Access Compliance Report

Public Rights-of-Way

(Curb Ramps)

Intersection ID: 2591	Main Street: BEARDSLEY_DR	Cross Street: HARTFIELD_DOWNS_DR	Location: NW
ADA ID: 443A86064958	Ramp Type: PerpDiag	Initial Pass/Fail: Fail	Overall Compliance: No
Codes/Mitigation Info/Possible Solution		Field Measurements/Component Compliance

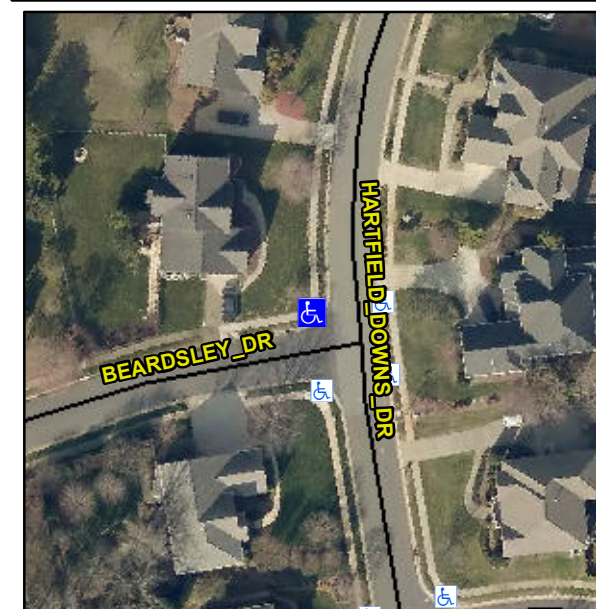
Remove & Replace Curb Ramp With Two New Directional Ramps or Equivalent.

R304.2.2
